SERVICE INFORMATION LETTER

SERVICE INFORMATION LETTER INDEX

SUBSIDIARY OF ISRAEL AIRCRAFT INDUSTRIES. LTD.
BEN GURION AIRPORT, ISRAEL

FIGURE 2

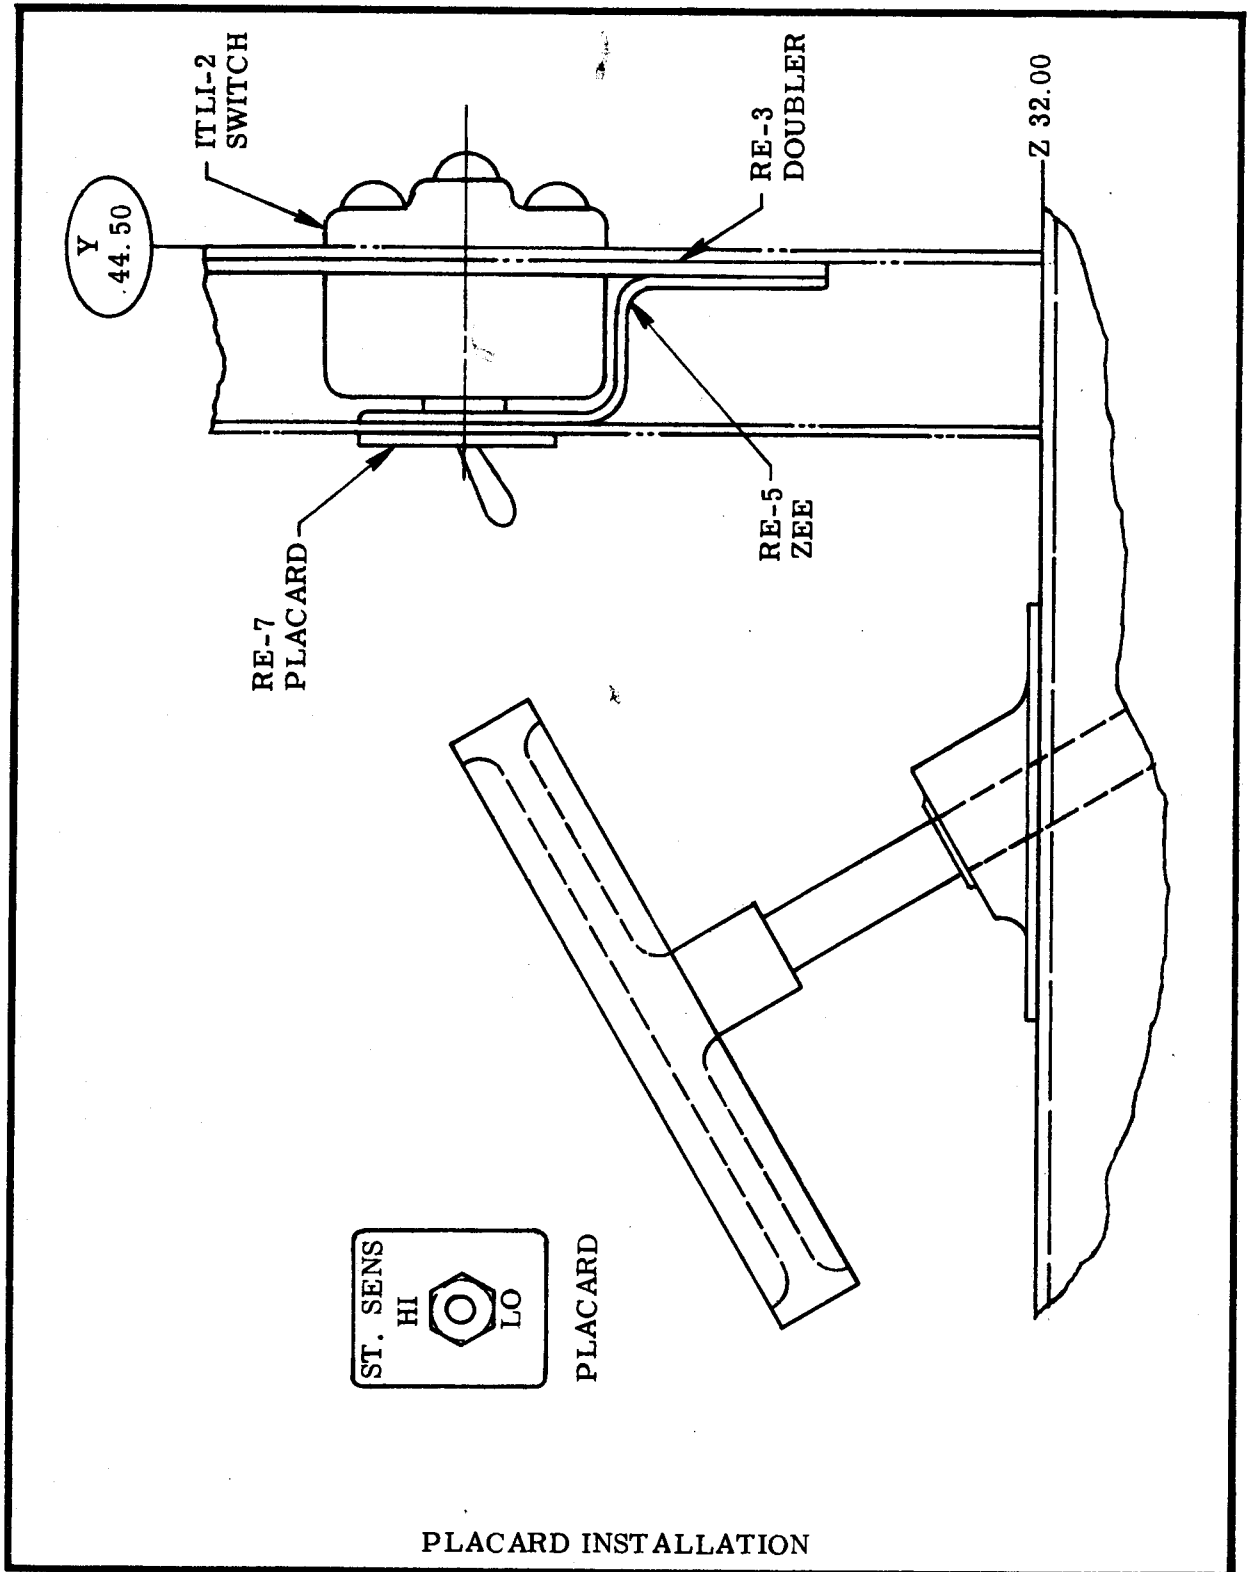
8. Remove side panel and drill 0.50 dia. hole through pilots side panel as marked. Bond the RE7 placard in place, using EC1403 cement or equivalent, as per Figure 2.

FIGURE 3A

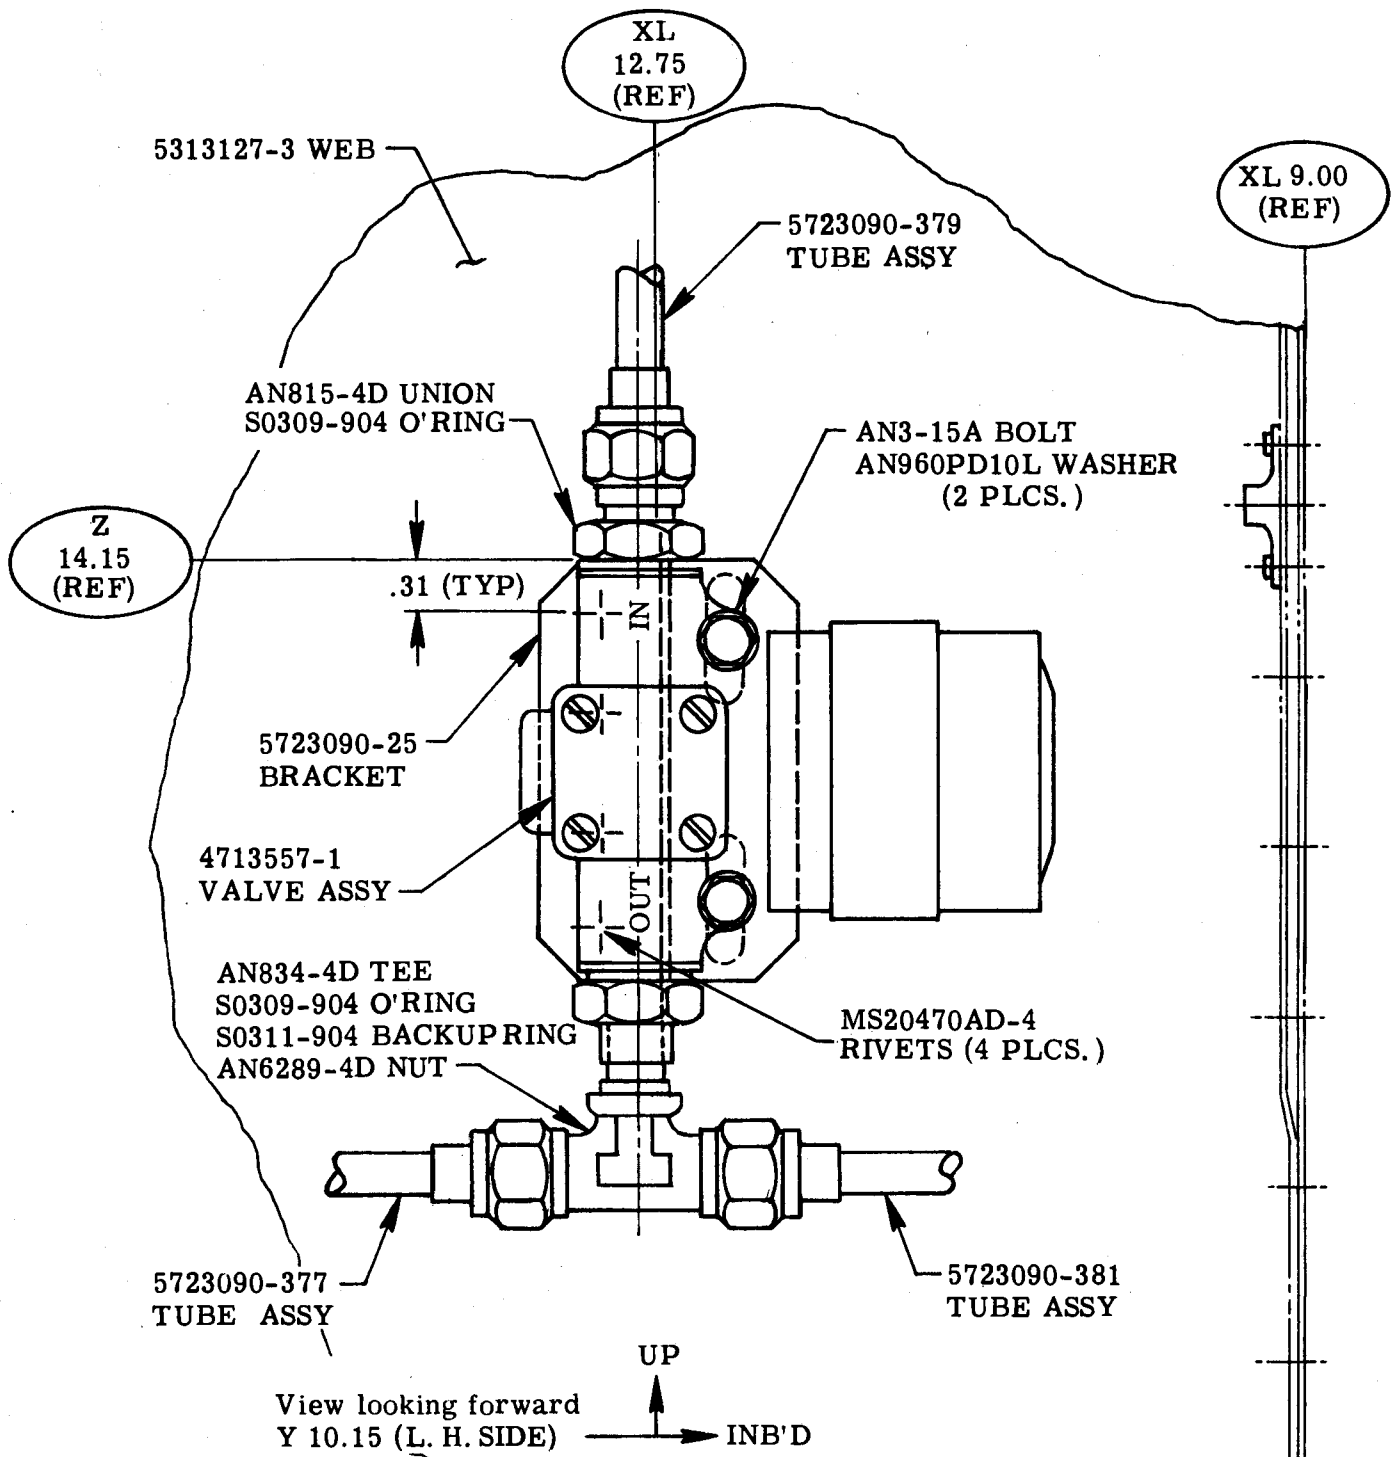
REASON FOR REVISION: TO CORRECT TUBING PART NUMBERS IN FIGURE 3A, CHANGE CONNECTOR PART NUMBER IN SUPPLY DATA AND ADD TUBE CLAMPING INFORMATION

1. Reference Figure 3A:
 - A. Tubing P/N 5723090-377 changed to 6723088-377.
 - B. Tubing P/N 5723090-379 changed to 6723088-379.
 - C. Tubing P/N 5723090-381 changed to 6723088-381.
2. The MS3106E-14S-9S Connector in Kit "B" is replaced by Connector P/N MS3456L-10SL-4S or MS3108B-10SL-4S.
3. Clamping information for tube P/N 6723088-349 or (-377) as applicable.
 1. Drill a 0.190 - 0.194 hole in the Y-10.15 bulkhead at the intersection of Fuselage Station X-16.0 and Z-21.6.
 2. Install hydraulic tubing support clamp P/N MS21919DG4, using an AN3-12A bolt, NAS43DD3-50 bushing and MS21042-3 nut.
 3. The required hardware for Para. 2 may be obtained from local source.

- B. Install the Solenoid Valve P/N 4713557-1 and the 5723090-25 bracket (Kit "B") as per Figure 3A.
13. Install the VXLA2500270D Restrictor with S0309-904 O-ring on the AN783-4D tee fitting, per Figure 4.

FIGURE 4

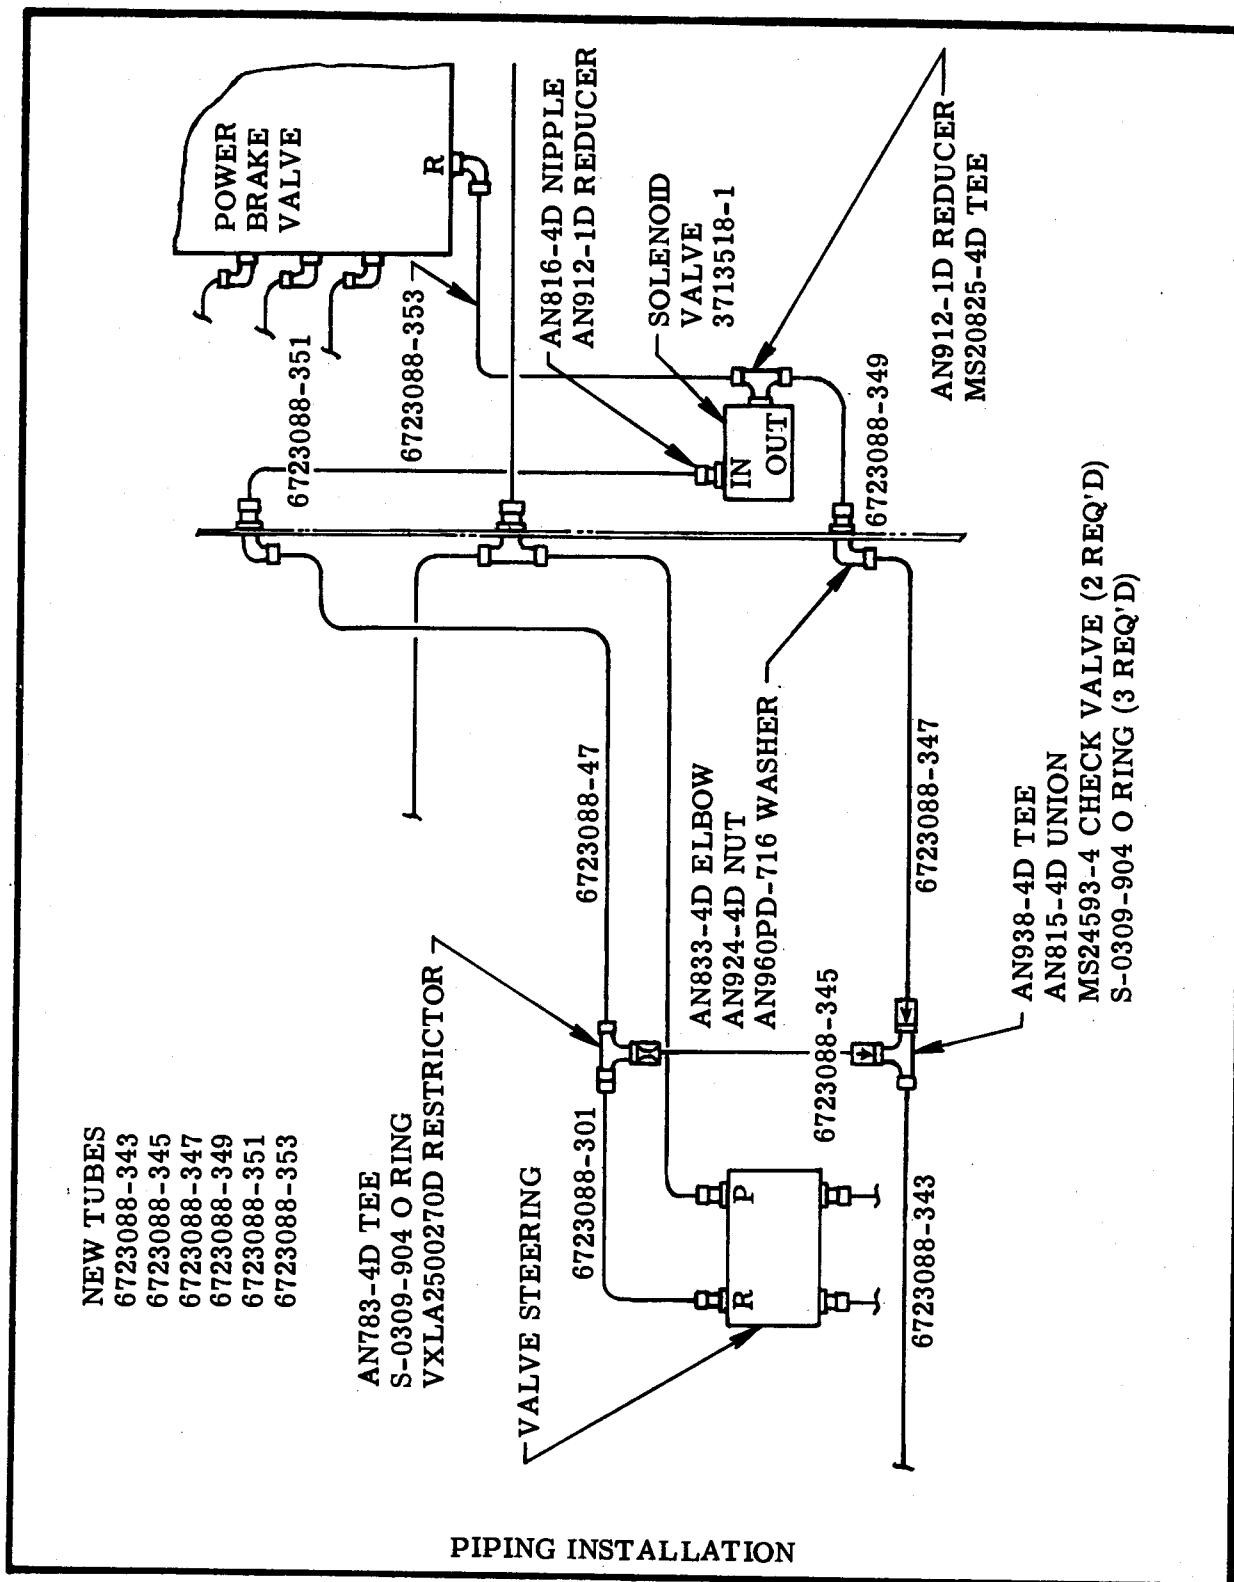
- C. The 6723088-115 tube assy between the 6-4TRTX-D reducer and the AN938-4D tee fitting that was removed in the preceding step. Discard tube assy.
15. Rearrange the configuration of the AN938-4D tee, the AN815-4D union and the MS24593-4 check valves, using new S0309-904 O-rings as per Schematic Figure 4.

16. Install the AN783-4D tee between the -47 and -301 tube assys, in lieu of the AN938-4D tee removed in Step 14 B, as per Schematic Figure 4.
17. Refer to piping installation Schematic Figure 4 (Kit "A") or Figure 4A (Kit "B"), and install new hydraulic return tubing between the nose steering valve, solenoid valve, power brake valve, and the hydraulic return tube at the AN824-6D tee and the 6-TRTX-D reducer, as per schematic.

FIGURE 1

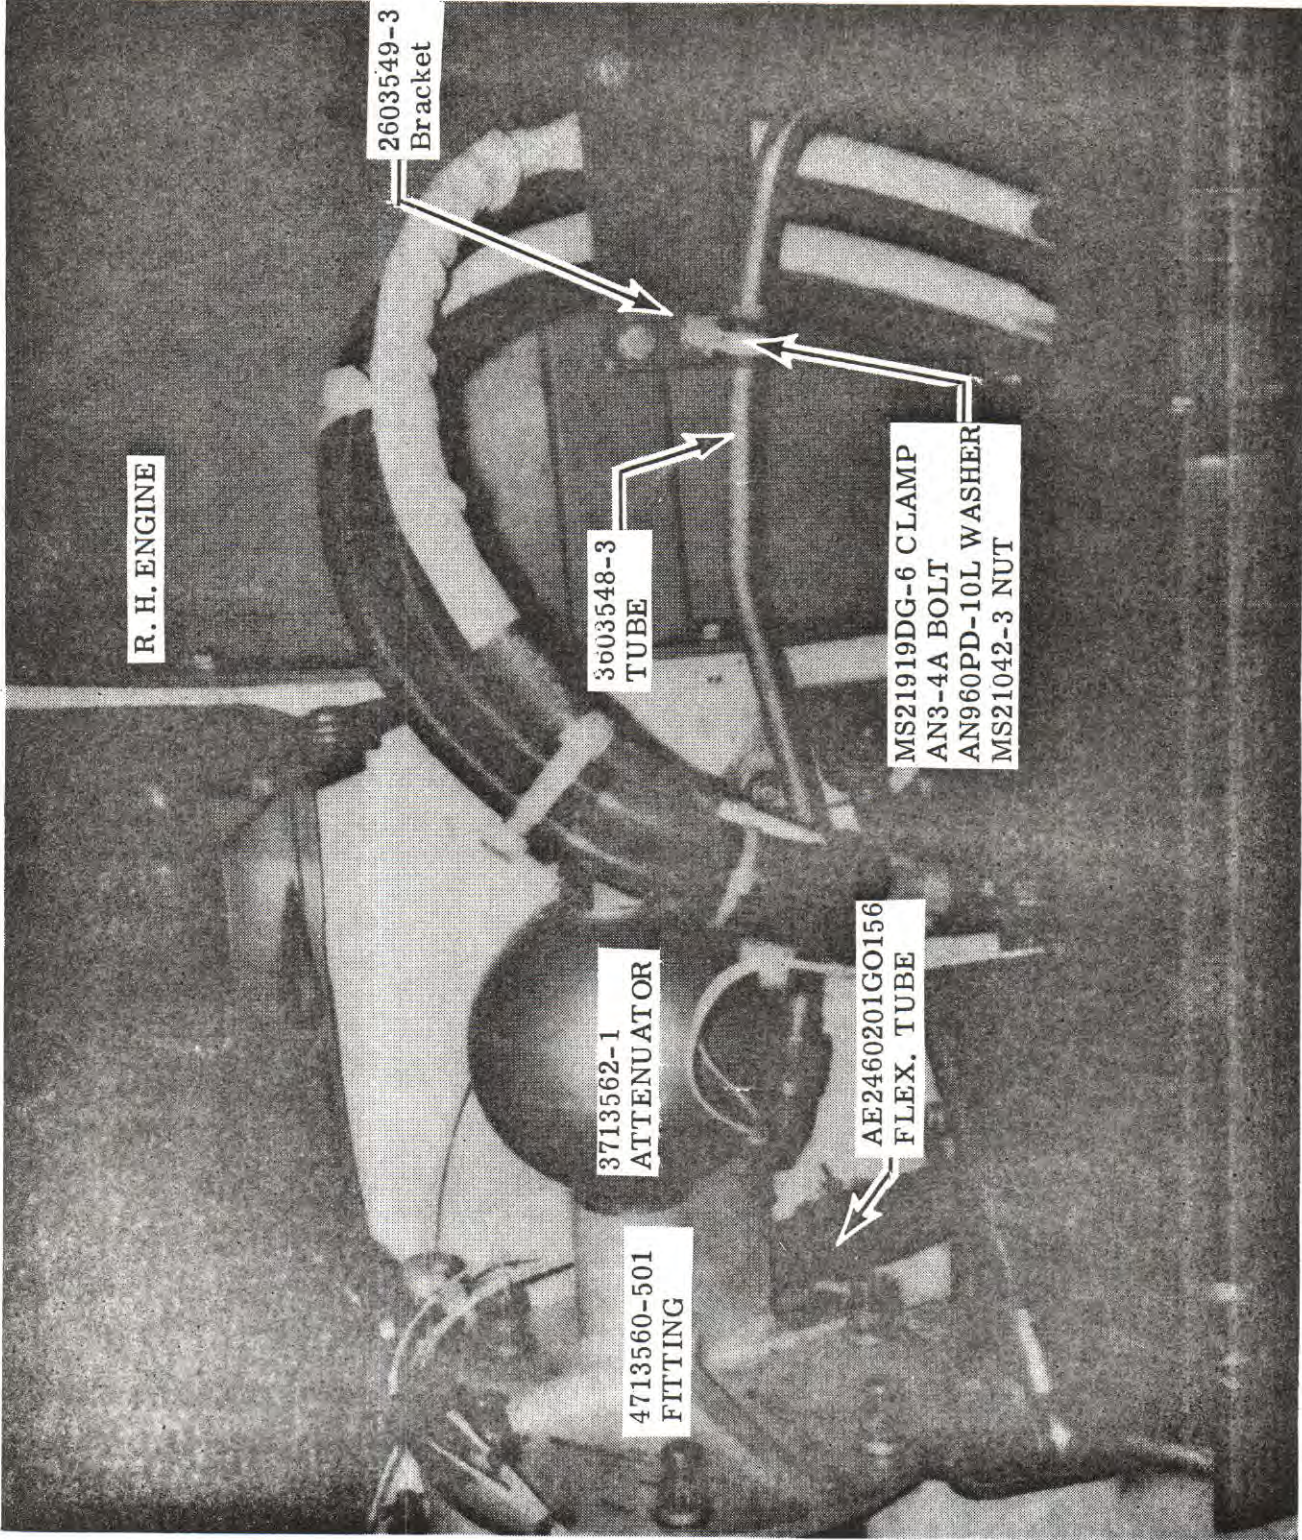
10. Remove and discard existing bracket P/N F10A-5-L20025-9, from right engine nacelle and replace with new bracket P/N 3603547-1. (See Figure 1).
11. Install an AN837-6J elbow, AN960C-916 washer, and AN924-6J nut on plate of bracket P/N 3603547-1, per Figure 1.

12. Install new flexible hose P/N AE2460201GO156 between R. H. hydraulic pump and inlet port of fitting P/N 4713560-501. (See Figures 1 and 2).
13. Secure hose to hydraulic pump mounting pad, with MS21919DG-14 clamp, AN3-4A bolt, AN960PD-10L washer, MS21042-3 nut and 2603550-3 bracket, per Figure 4.

FIGURE 2

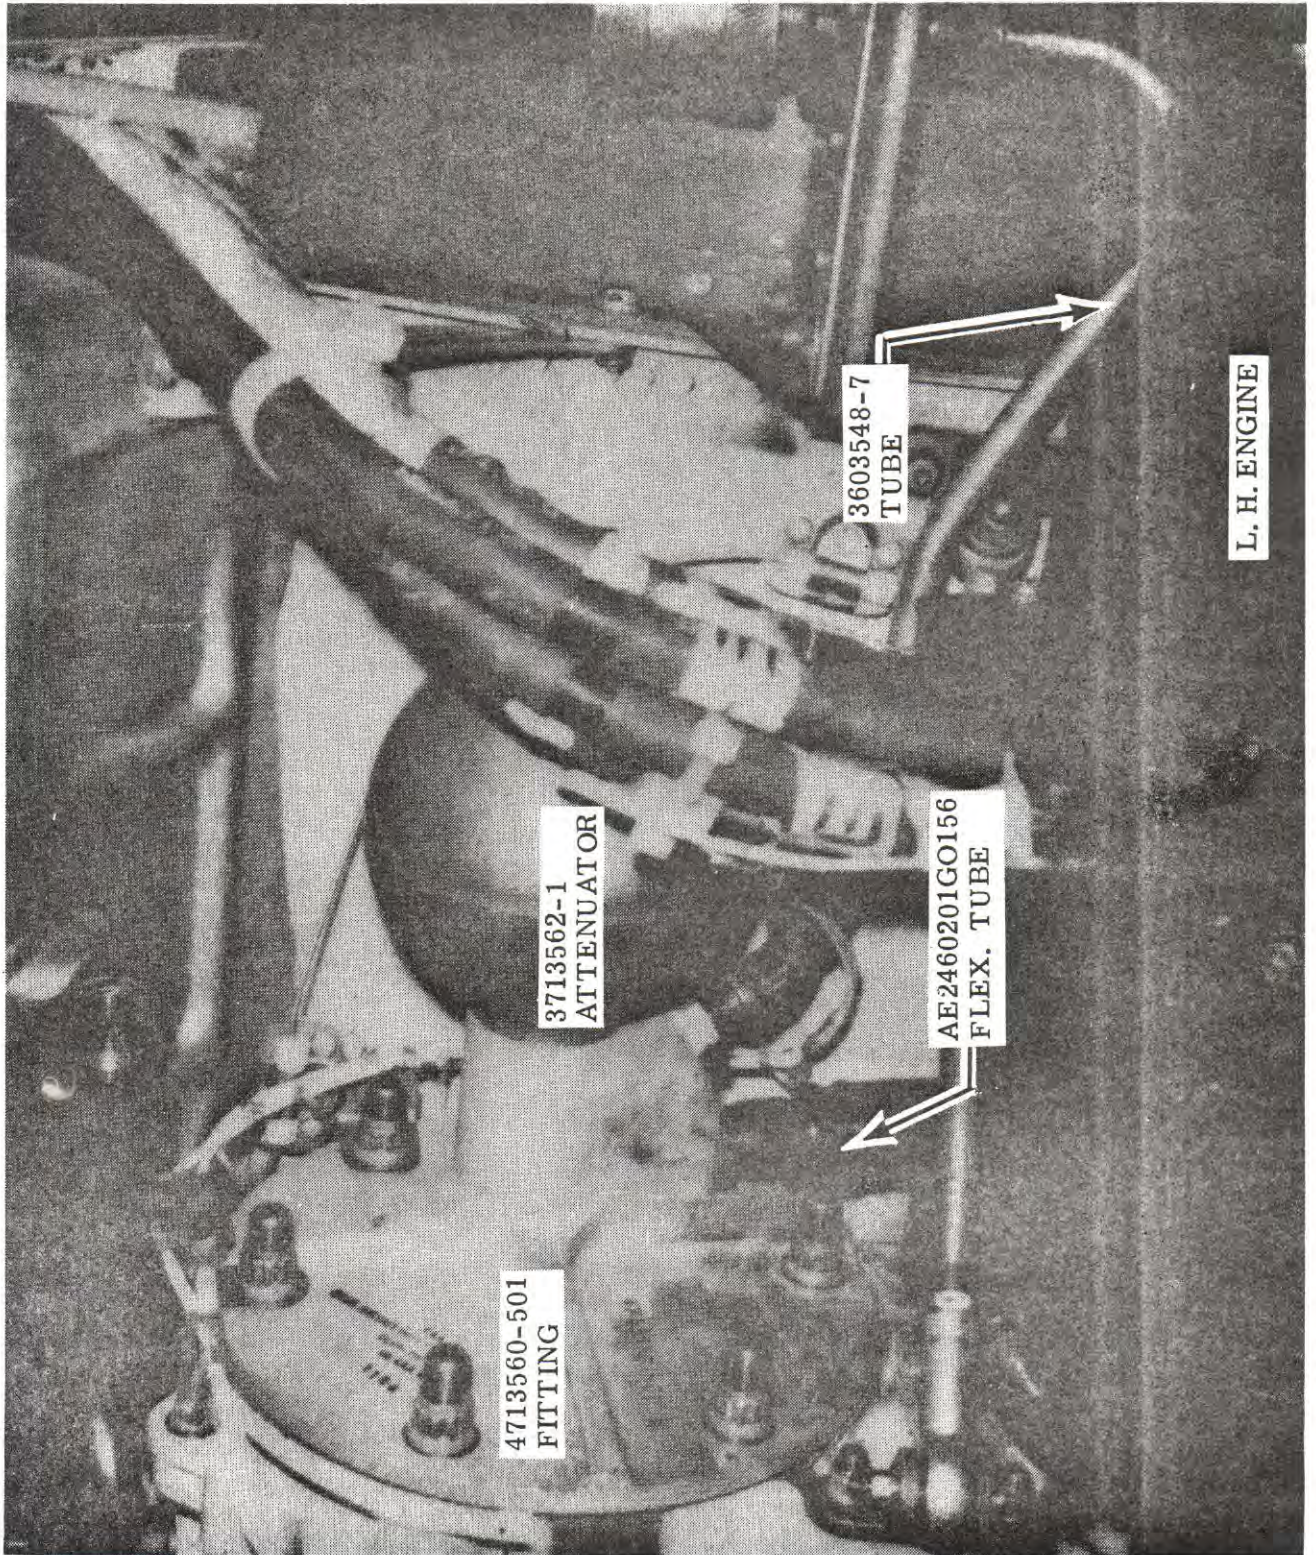
14. Install new tube P/N 3603548-3 between outlet port of fitting P/N 4714560-501 and the AN837-6J elbow, which was installed in Step 11.
15. Secure tube to wiring support block with MS21919DG-6 clamp, AN3-4A bolt, AN960PD-10L washer, MS21042-3 nut, and 2603549-3 bracket, per Figure 2.
